From: Jack Bell <jackbell@lukenbeck.com>
Sent: 16 April 2024 14:38
To: Harrison, Liz
Cc: Ian Johnson; Daryl Roberts; Aidan Robson; David Lawrence; Sandy Barnes
Subject: Re: DC/21/91472, DC/23/94483 and DC/23/95471 - Network Rail response re: drainage
Attachments: M434 57E Surface Water Detention Basin D.pdf

Subject: Re: DC/21/91472, DC/23/94483 and DC/23/95471 - Network Rail response re: drainage

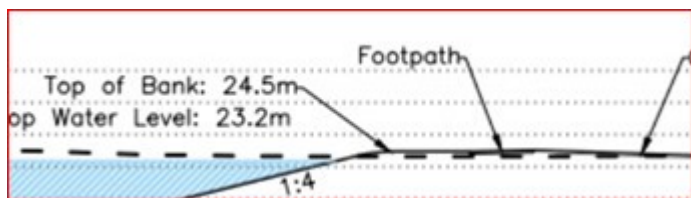
Key to NR at this stage, is the exceedance routing and the pond design. An extract from the drawing for Basin D is provided below showing the top of bank adjacent to the railway as 24.5mAOD, this appears to be incorrect and the lowest ground levels at the bank on this side are around 23.5mAOD. As all exceedance routing for the phase is shown to be to the pond and then to the railway, it is critical that that the amount of capacity in the pond above the modelled top water level of 23.2mAOD is demonstrated, and levels built up (with appropriate construction methodology) if necessary.

The top of bank to the pond is not the existing ground level, it is a proposed ground level – the ground will be lifted to attain the required level. In the extract below, the existing ground is the dashed line, the proposed ground is a continuous line;
